March 24, 1982
TAAG-0008

ASSESSMENT OF DEFUELING PLAN

FOR THREE MILE ISLAND, UNIT 2

III. COMMENTS ON BECHTEL NATIONAL'S TECHNICAL PLAN FOR REACTOR DISASSEMBLY
AND DEFUELING REVISION 2, DATED JANUARY 1982

FIGURE V-3 TMI #2
 DRAINING OF SECONDARY SIDE OF "A" OTSG

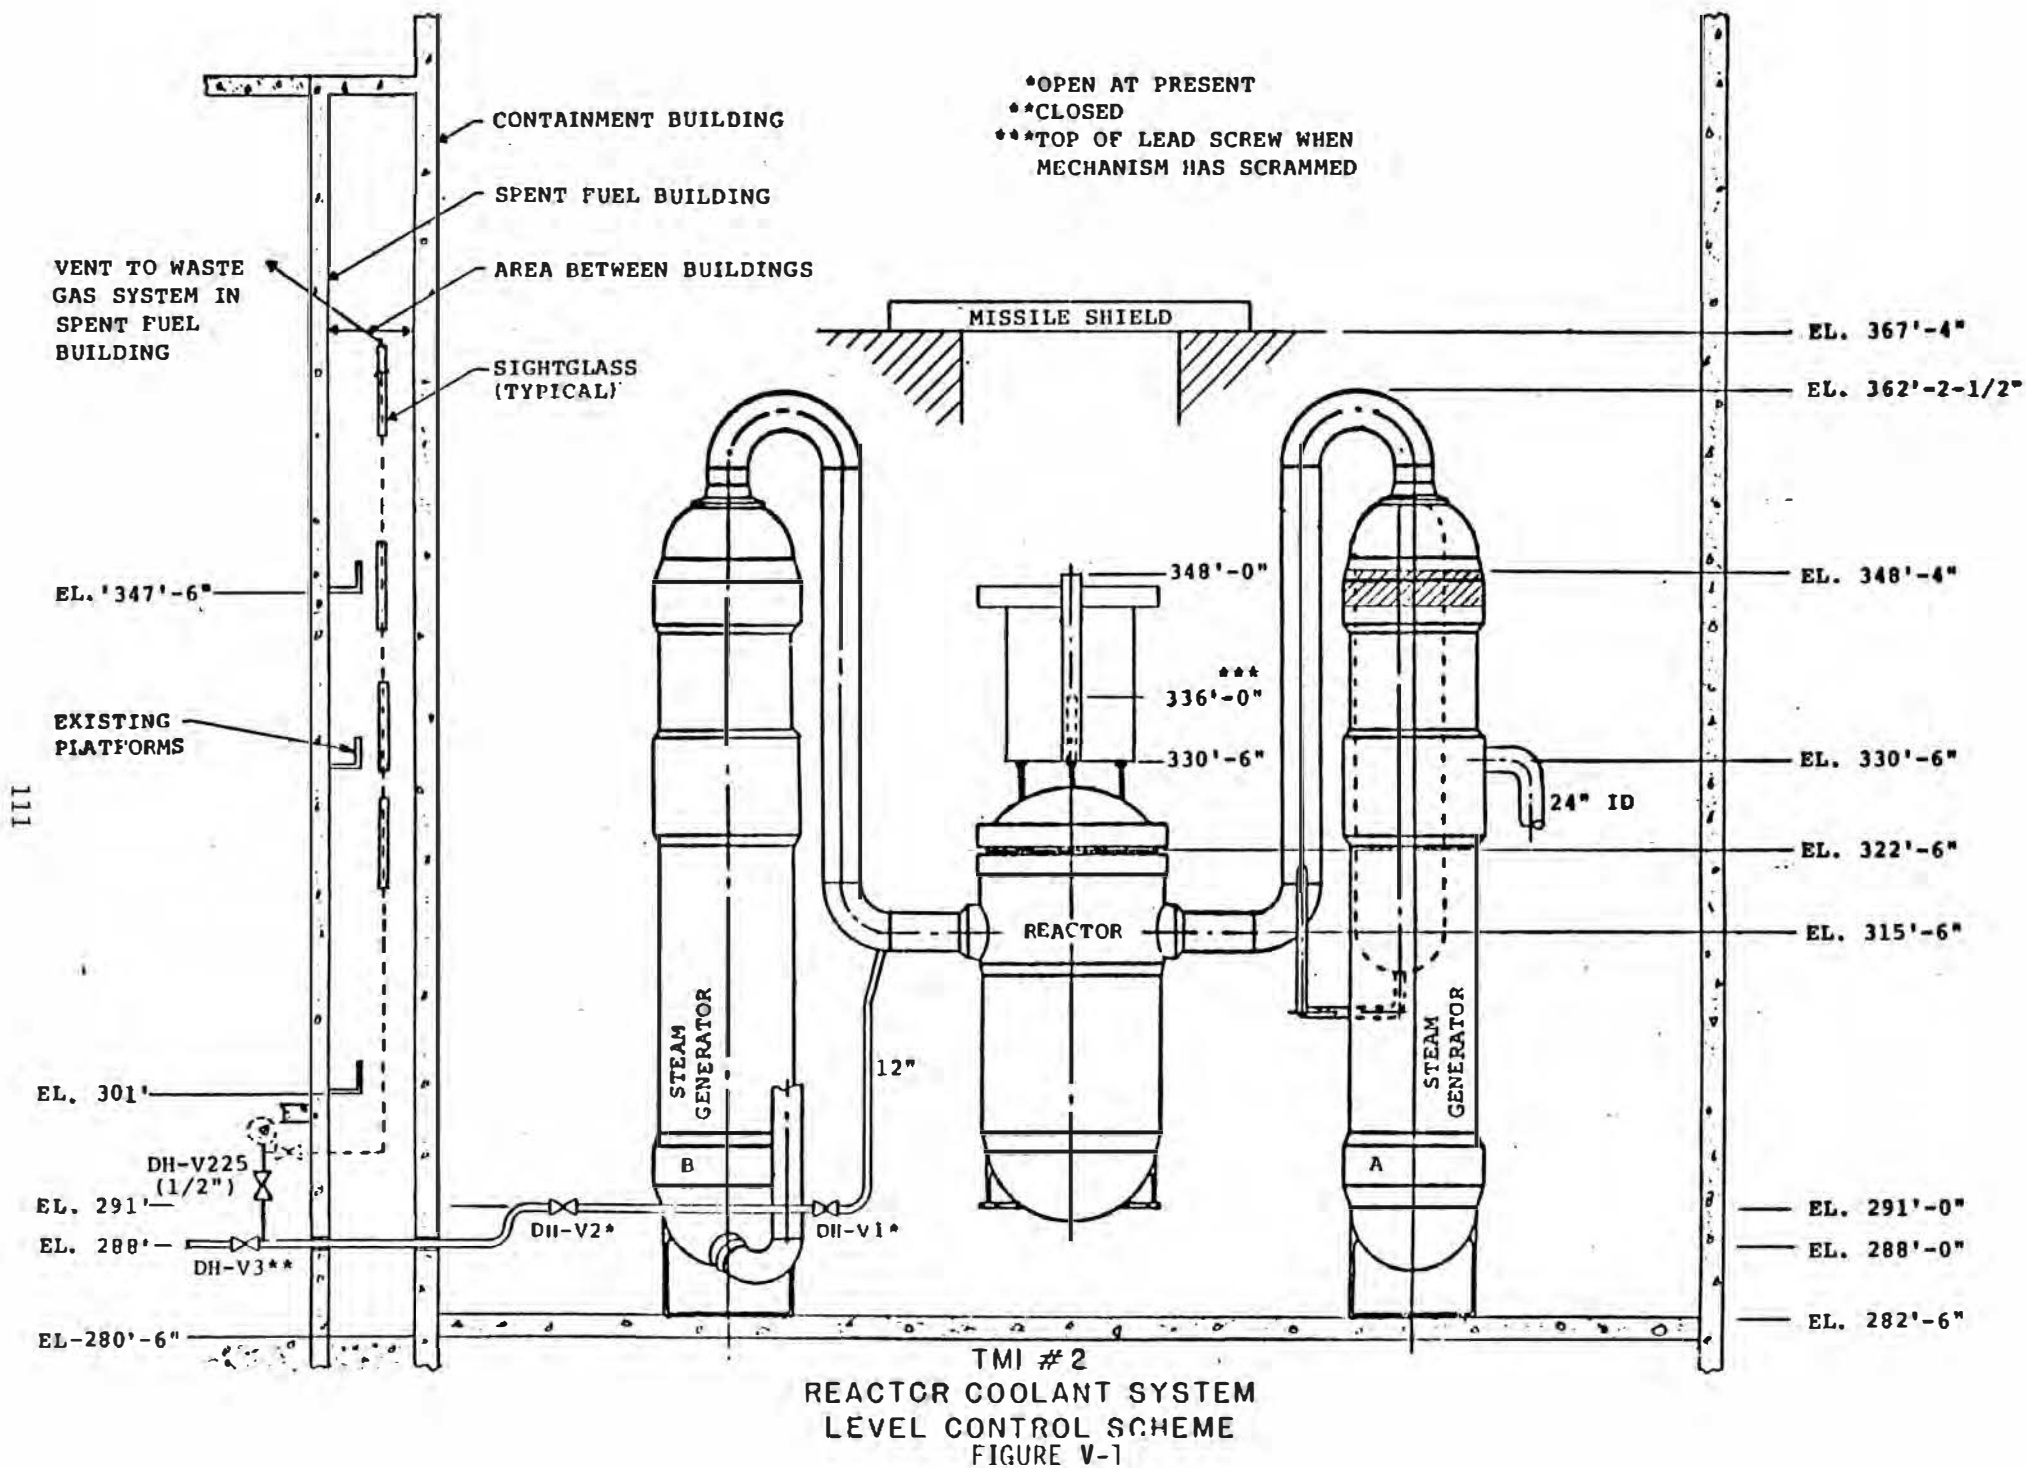
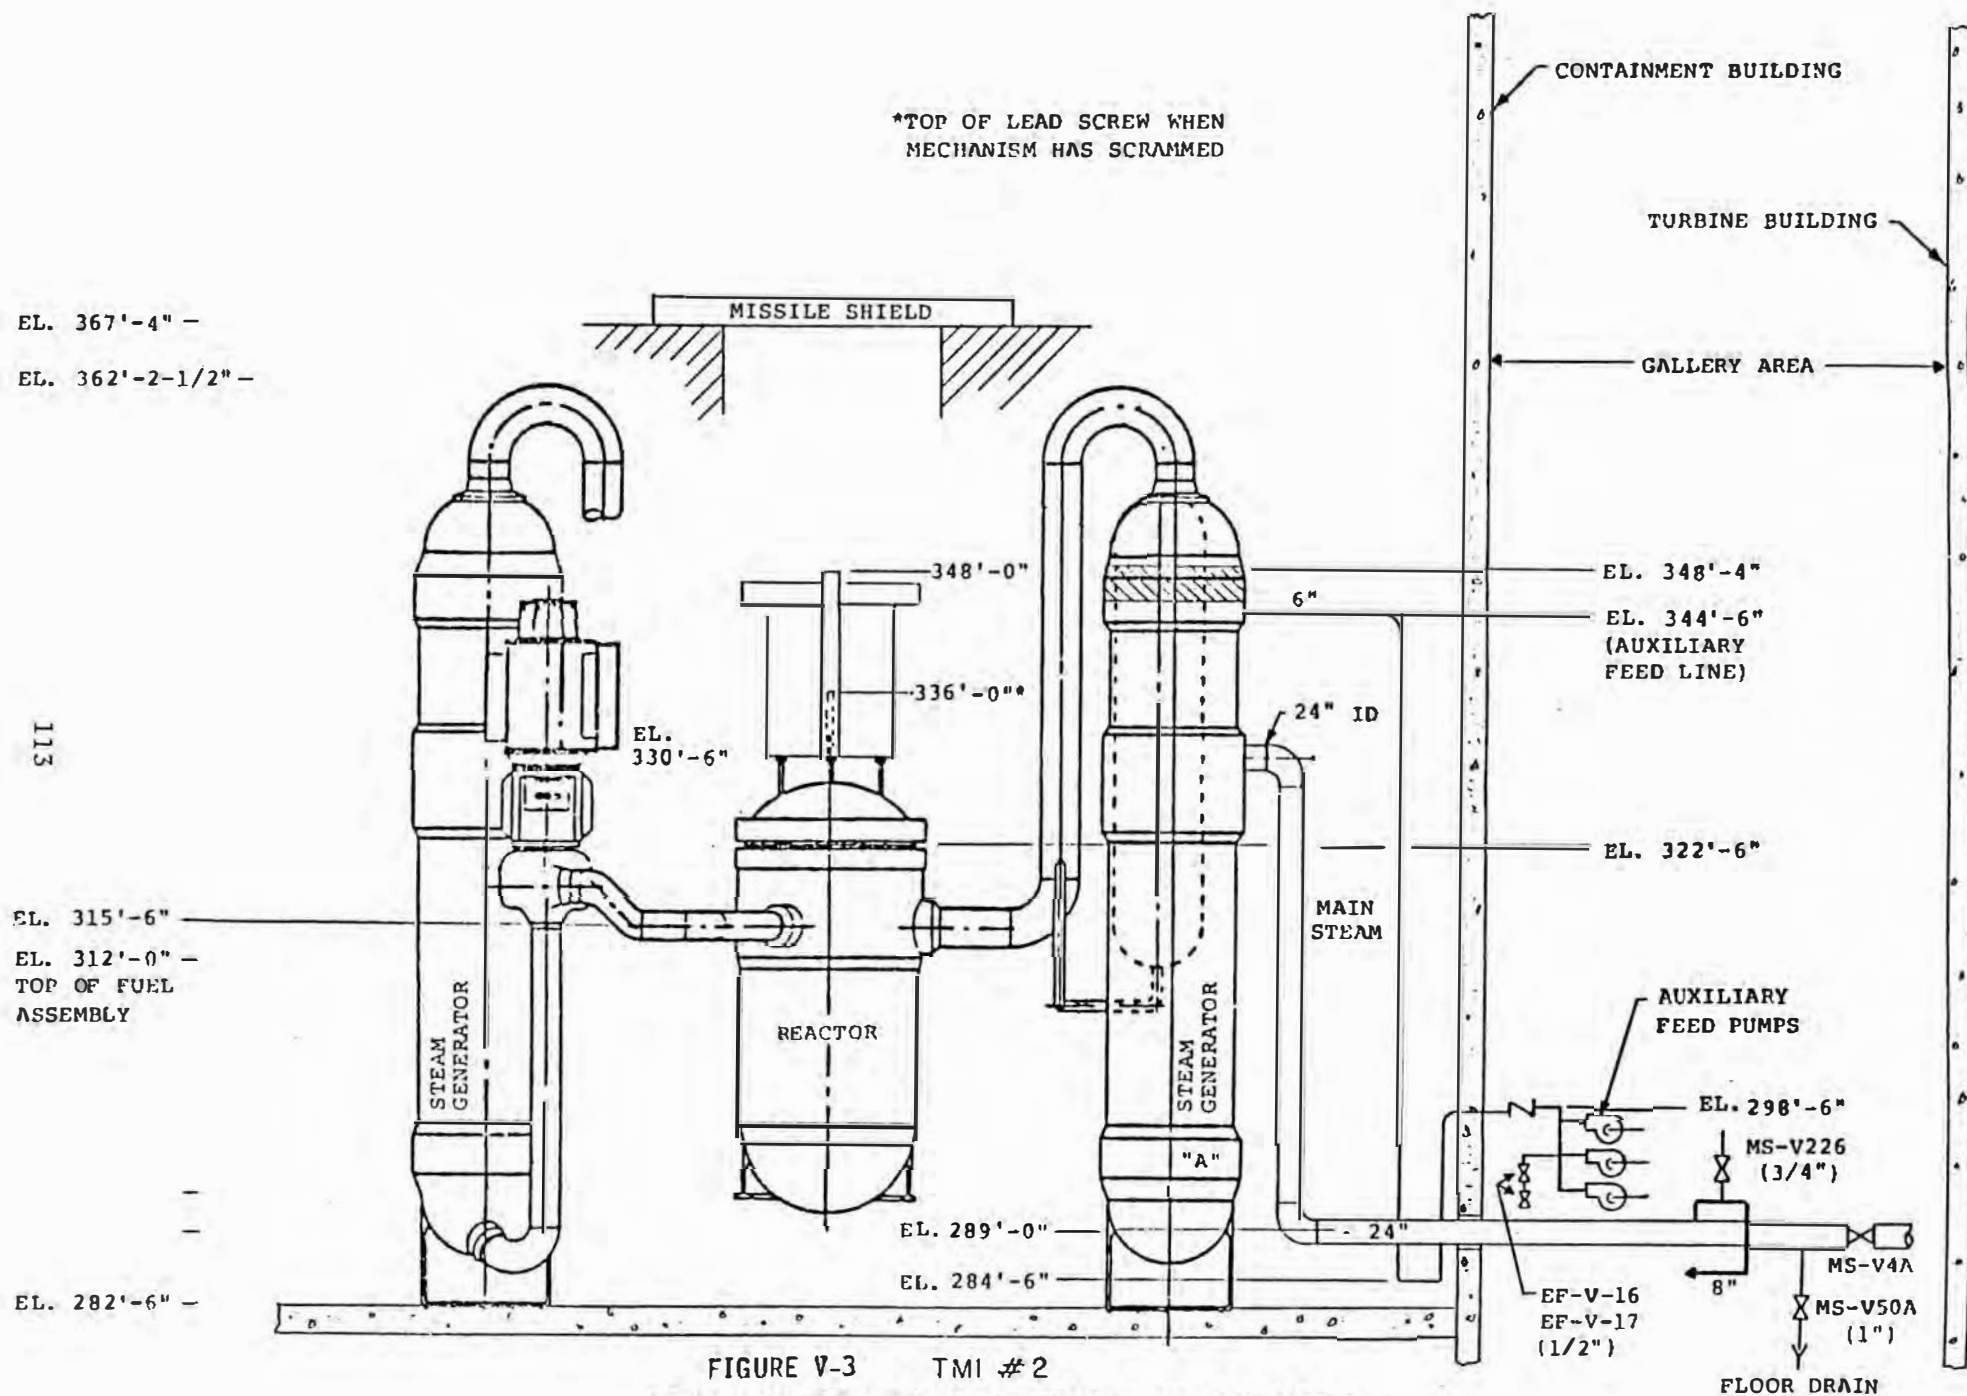
If the secondary side water level can be drained to the bottom of the main steam nozzle (EL. 329'-6") and the water level in the reactor coolant system drained down (EL. 335') to release the leadscrew, then the primary coolant will still be approximately five feet above the secondary side water level (see Figure V-5). With such a water level configuration, those issues concerning the steam generator that could lead to the remote possibility of recriticality of the core are avoided.
